DOCUMENT 00914

ADDENDUM NUMBER 04

Project name: New Legislative Parking Garage
State Project Number: 81284-B
Project Address: 33 CAPITOL STREET
CONCORD, NH 03301

sheet no.
C1.02

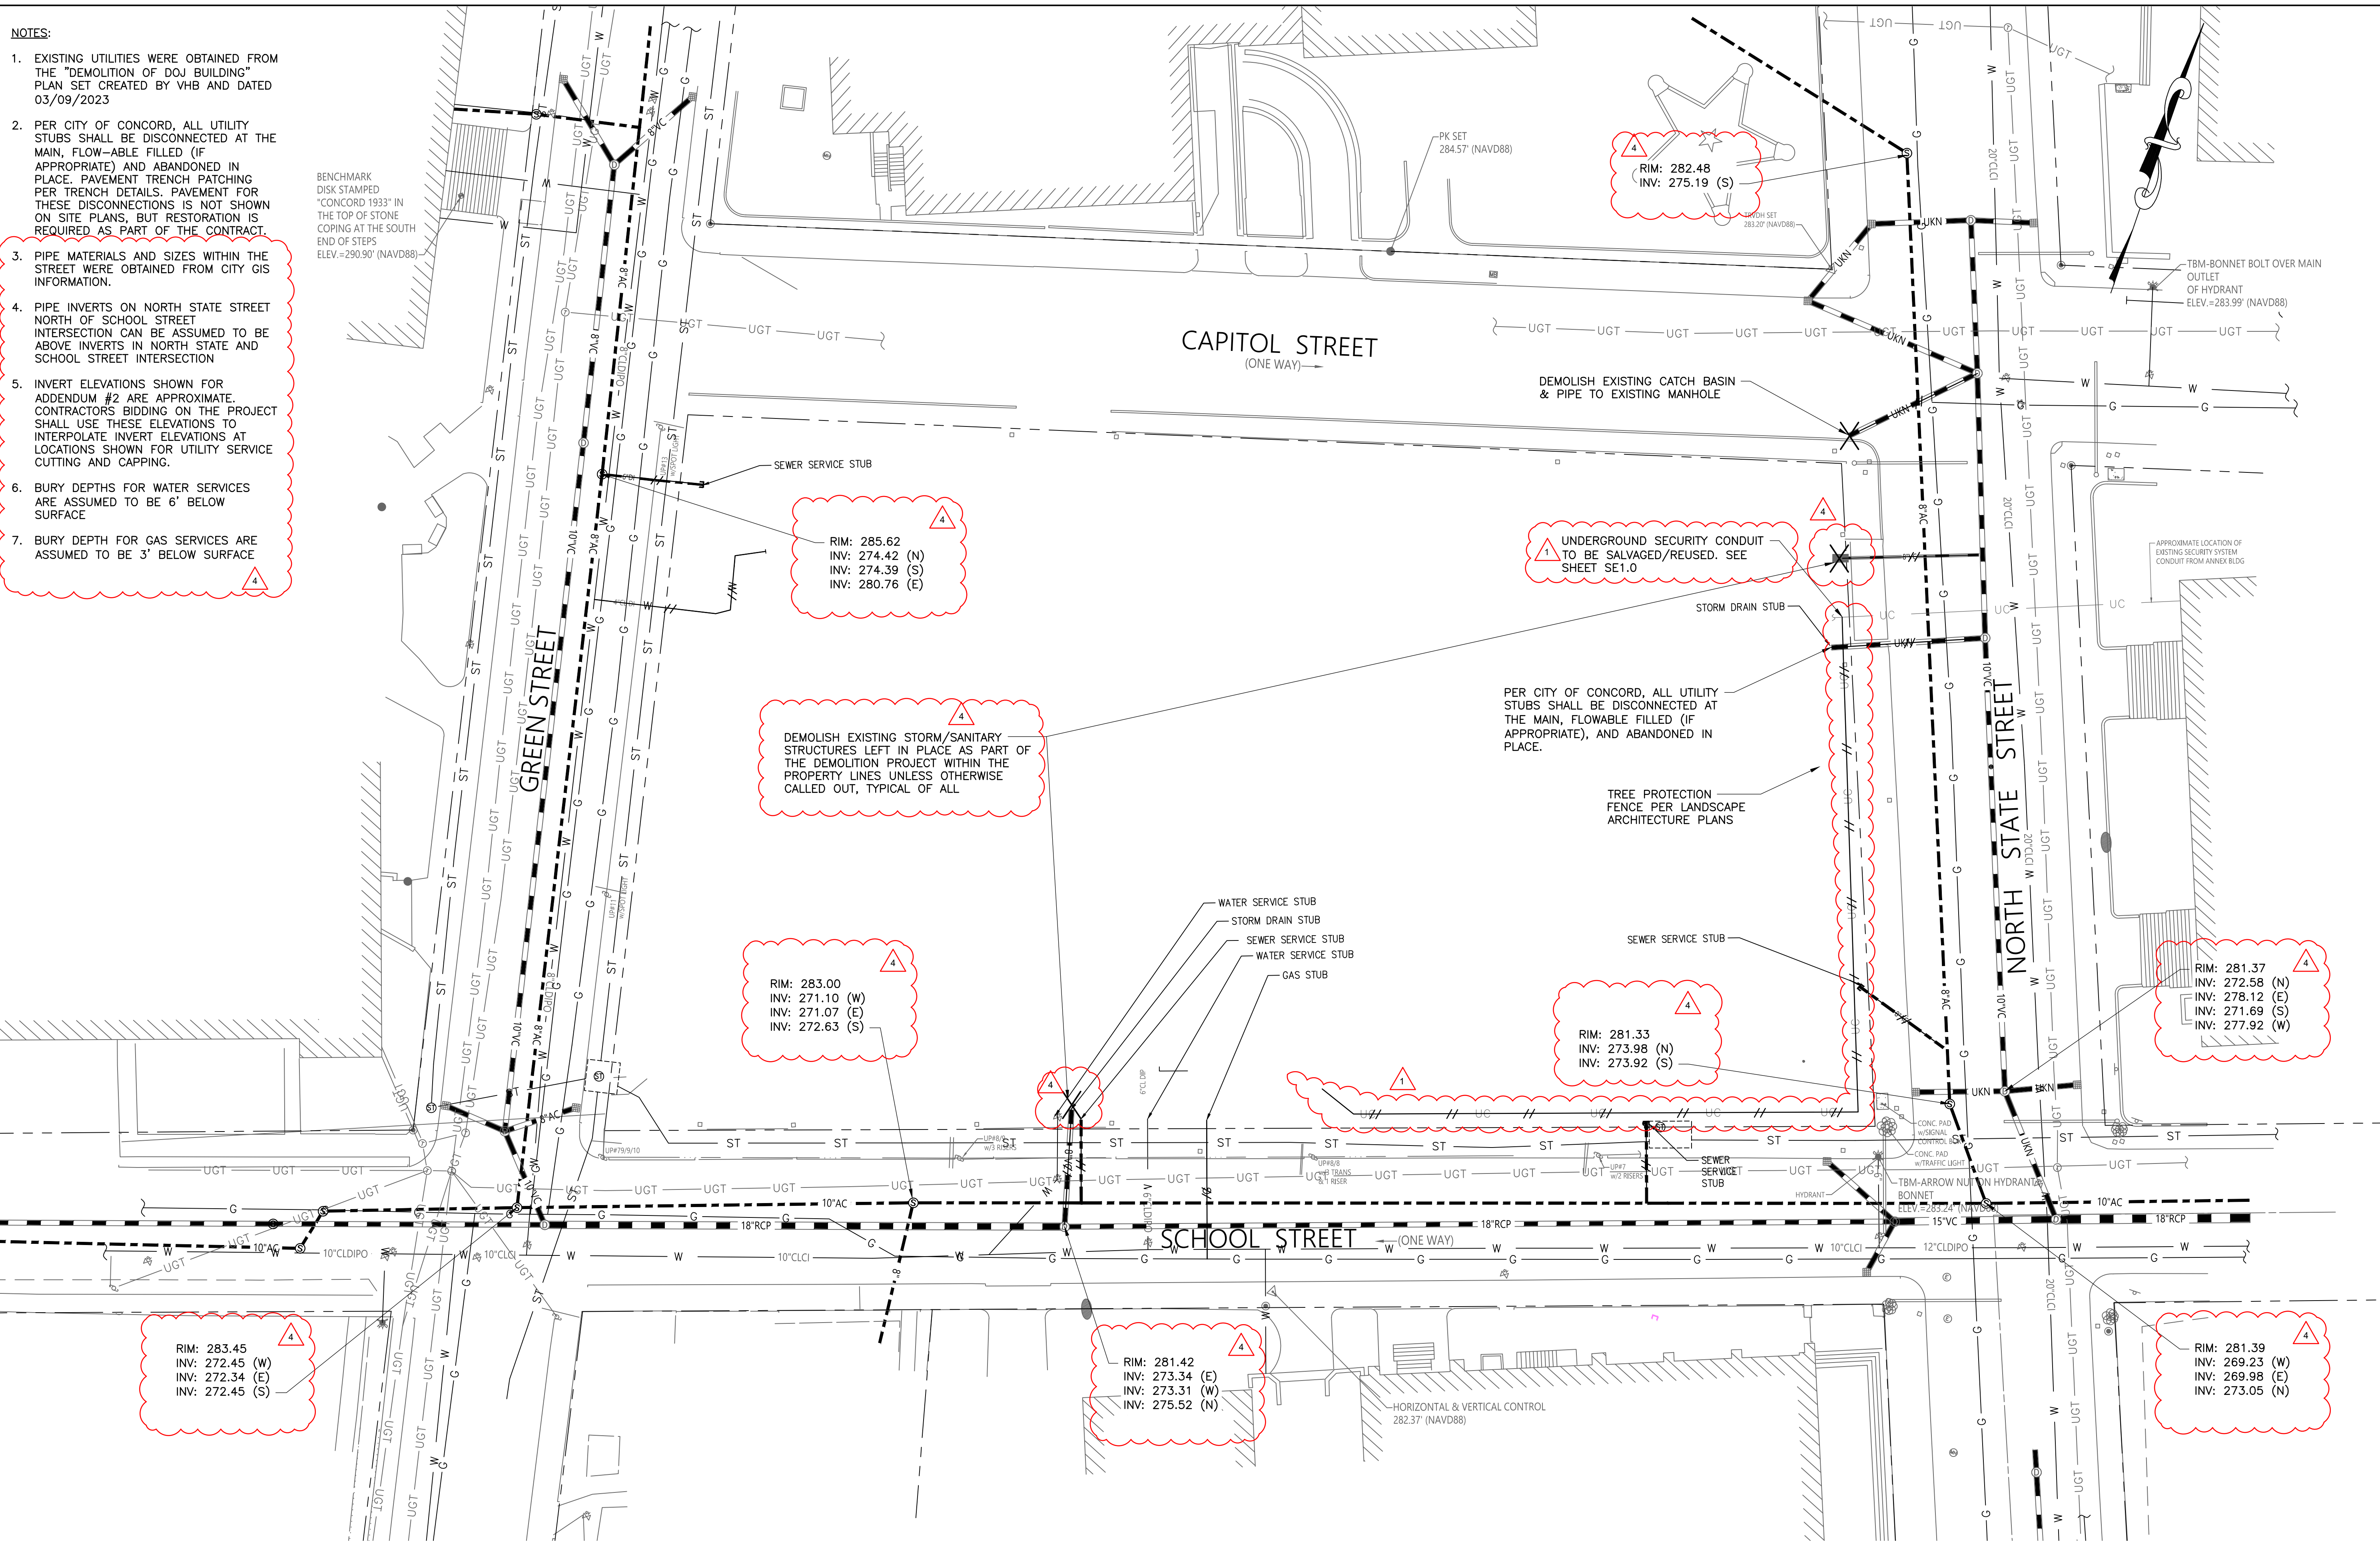
1. Q: Please confirm Sewer Rim, inverts, and lateral elevations for cut and cap purposes on Green St, School St, and North State St.
A. Please refer to C1.02 attached to this Addendum.
2. Q: Please Confirm water lateral elevations on School St, and Green St for cut and cap purposes.
A. Please refer to C1.02 attached to this Addendum.
3. Q: Please confirm drainage rim, invert, and lateral elevations for cut and cap purposes on School St, and North State St.
A. Please refer to C1.02 attached to this Addendum.
4. Q: Security grates at first level, and at ramp openings: 1/A7.7 calls for 1/2x1/2 pickets yet A6.0 and the finals call for 3/4x3/4 pickets.
A. Pickets need to be sized to fit the finials. Either 3/4" balusters for a 3/4" finial or 1/2" balusters for 1/2" finials are acceptable. The grates are a delegated design item so overall structural

19. C1.02 Existing Underground Utility Plan
 - A. Replace drawing updated in Addendum 1 with version re-issued in this Addendum. Scope changes include demolition of two existing catch basins and RIM/Invert elevations of existing piping and structures.

SK-OHP

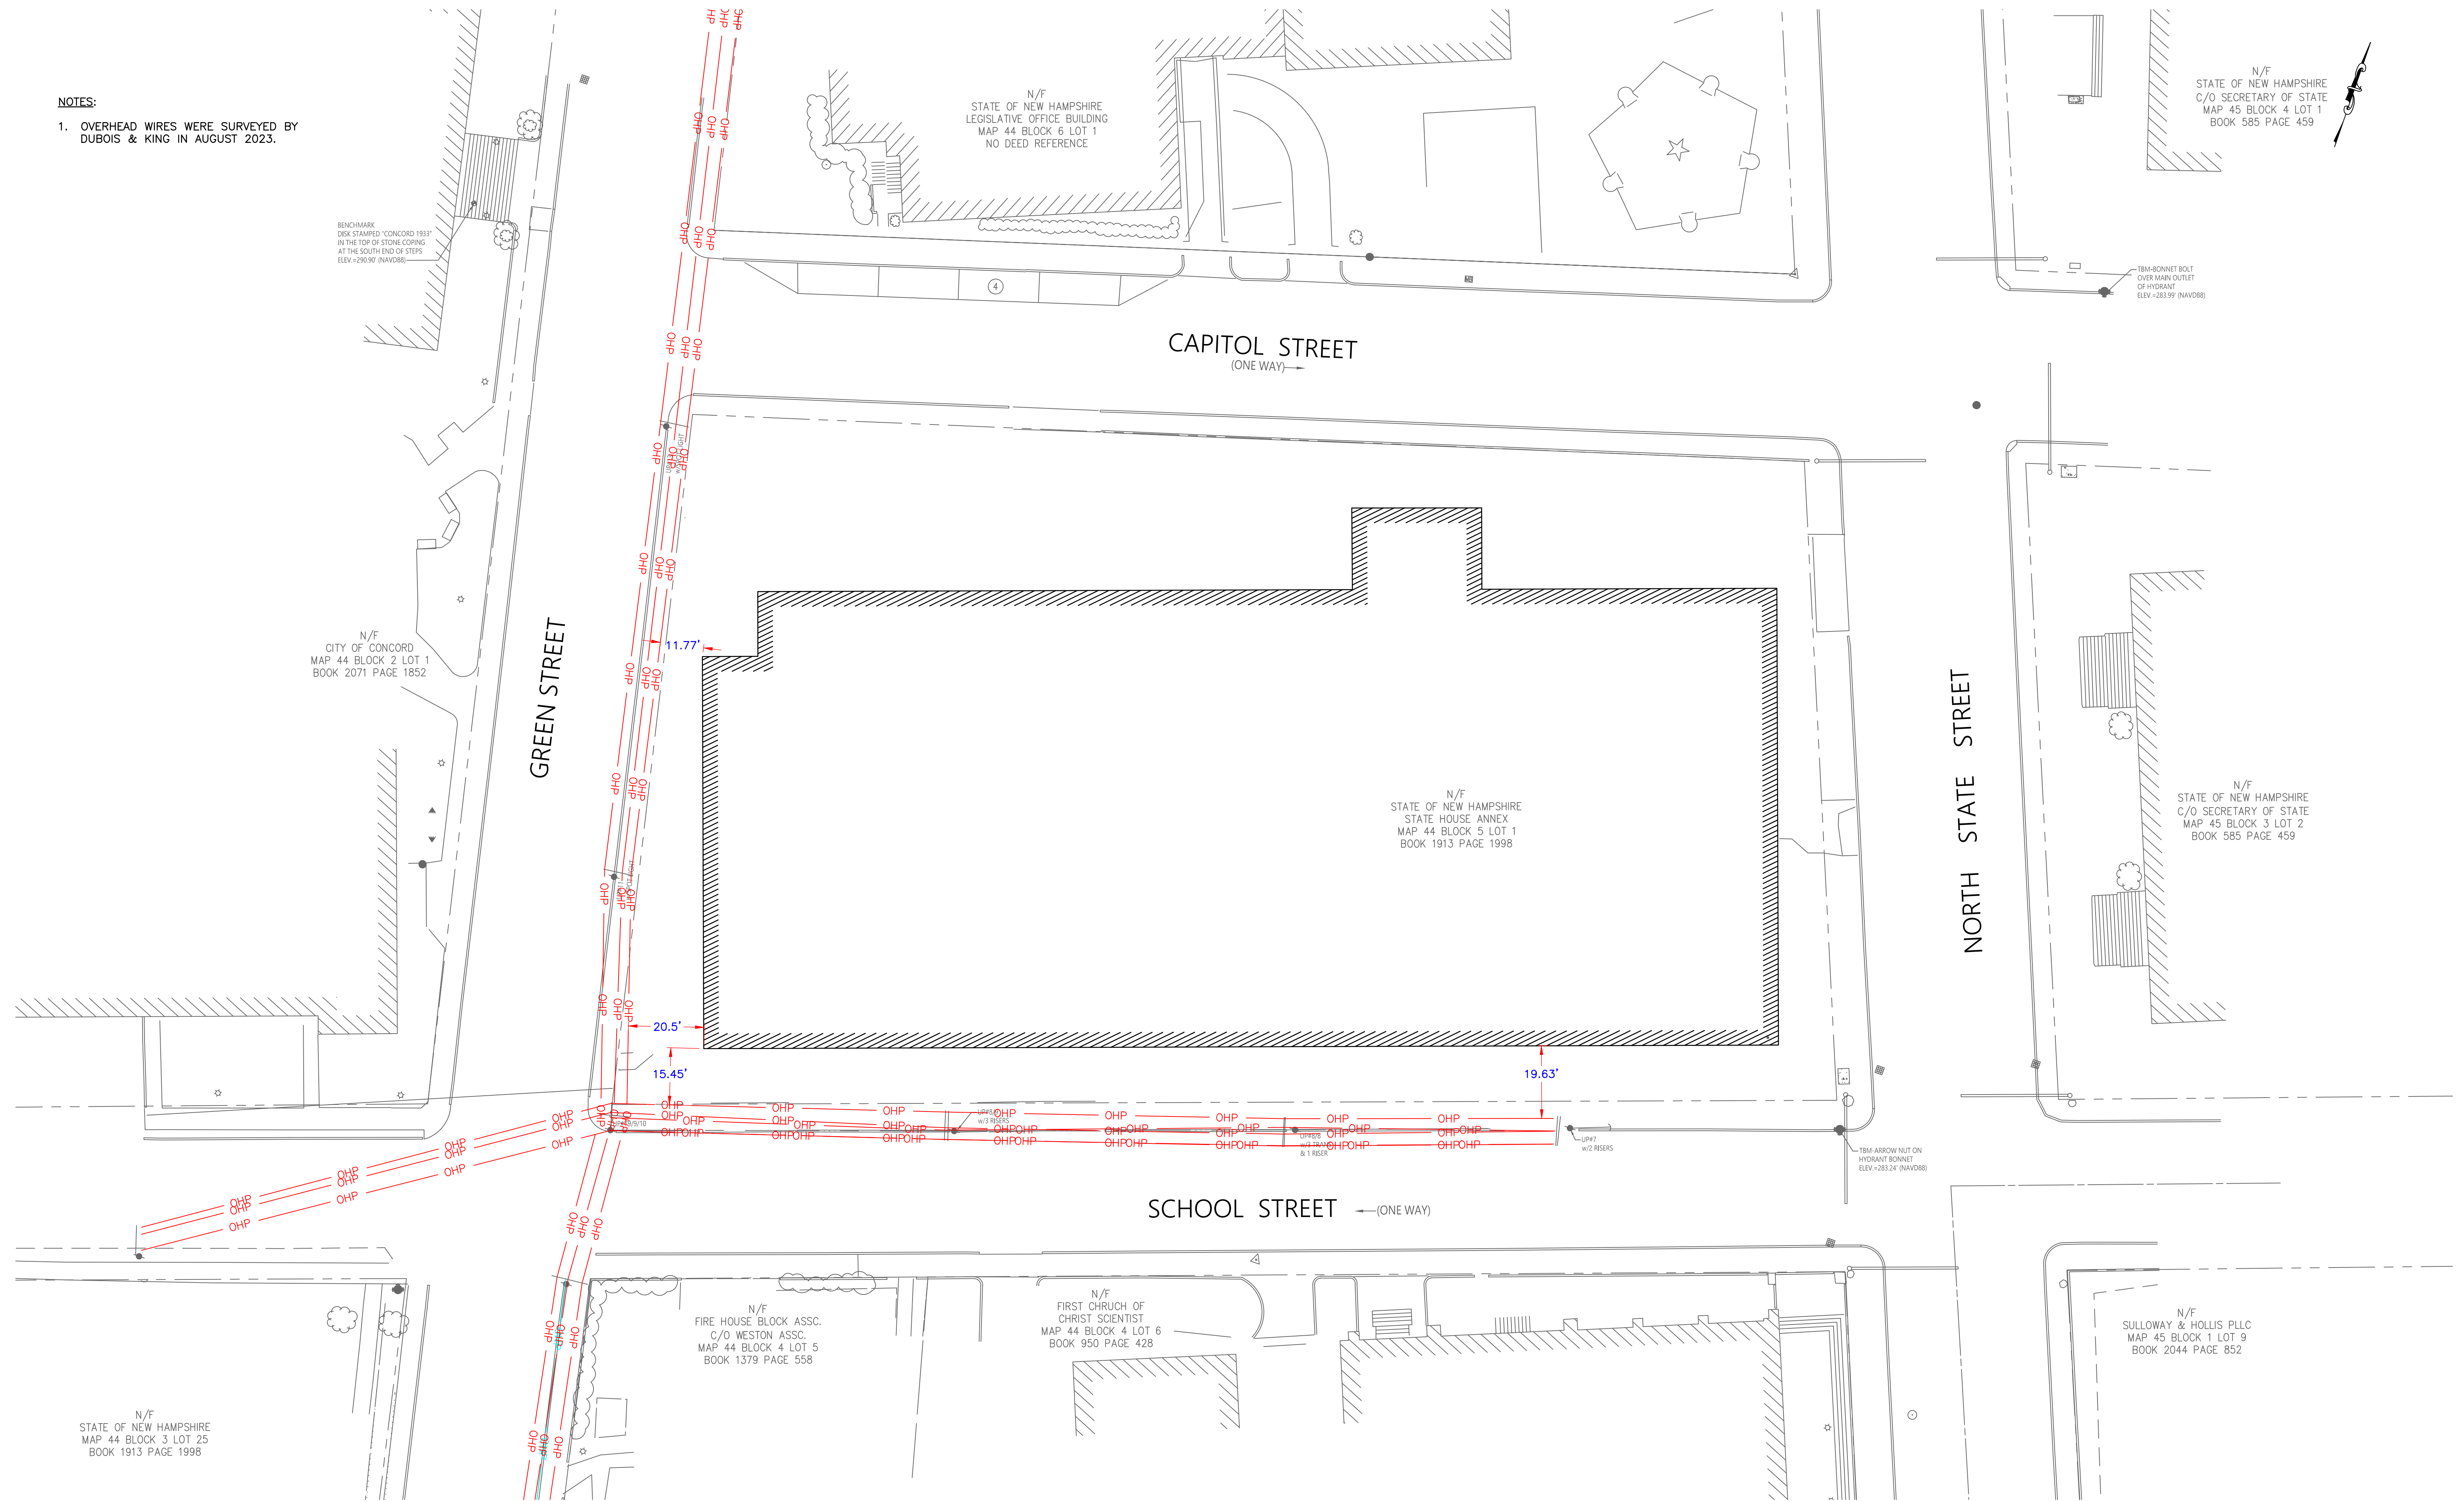
8. Q: In Addendum #3 it was noted that OSHA requires 10' clearance from a protected power line. This works for precast erecting, but installing the GFRC's and lighting will encroach on the 10' clearance. Please advise how we to install GFRC's and Lighting and still be OSHA compliant. (This question is related to Addendum #3 Question 10)

A. Please refer to SK-OHP for surveyed power line locations and distance to building along School Street and Green Street. The closest line is predominantly 15'-20' from the building giving enough room to comply with the OSHA safety requirement. The smallest distance is 11'-9.25" at the NW corner. The GFRC entablature projects 1'-8" from the building. For bidding purposes include installation of all GFRC entablature pieces based on the presumed ability to comply with OSHA by installing shorter sections at a time if necessary.
